Access Compliance Report Public Rights-of-Way (Curb Ramps)

Main Street: O_NEILL_DR Cross Street: CREIGHTON_DR Location: E

ADA ID: RPRK211026142345 Ramp Type: Type 4 - Parallel Initial Pass/Fail: Fail Overall Compliance: No Severity Score: 15

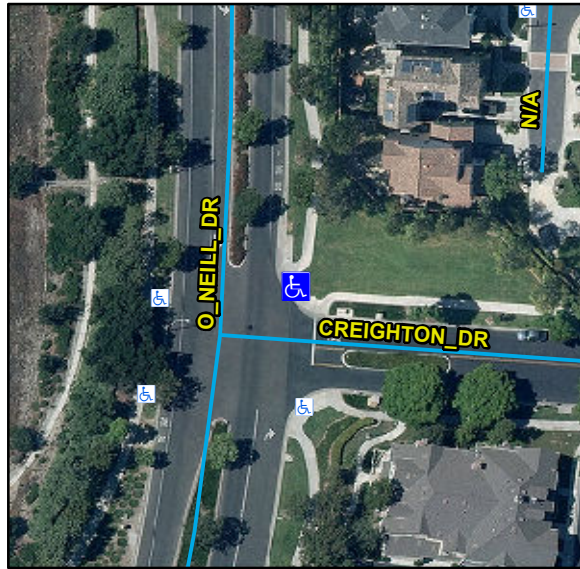
R204.3, R304.3.2, STD 1115

Compliance	Description	Data	Compliance	Description	Data
N/A	Ramp Length LT (in)	127	N/A	Ramp Length RT (in)	128
Yes	Ramp Width LT (in)	90	Yes	Ramp Width RT (in)	90
No	Ramp Run Slope LT (%)	10.1	Yes	Ramp Run Slope RT (%)	1
Yes	Ramp Cross Slope LT (%)	0.9	Yes	Ramp Cross Slope RT (%)	1.8
N/A	Landing Present	N/A	N/A	DWS Provided	N/A
N/A	Landing Length (in)	N/A	N/A	DWS Contrast	N/A
N/A	Landing Width (in)	N/A	N/A	DWS Length (in)	N/A
N/A	Landing Run Slope (%)	N/A	N/A	DWS Full Width	N/A
N/A	Landing Cross Slope (%)	N/A		DWS Offset Type	N/A
N/A	Landing Movement Obstructed?	N/A	N/A	DWS Offset Left (in)	N/A
	Landing Movement Type	N/A	N/A	DWS Offset Right (in)	N/A
N/A	Landing Shared	N/A			
N/A	Clear Space	Yes			
N/A	Clear Space To Crosswalk (in)	N/A			
N/A	Marked Crosswalk 1	No	N/A	Marked Crosswalk 2	No
	Crossing 1 Direction	NW		Crossing 2 Direction	SW
	Marked Crosswalk 1 Width (in)	N/A		Marked Crosswalk 2 Width (in)	N/A

Remove & Replace Curb Ramp With Two New Directional Ramps or Equivalent.
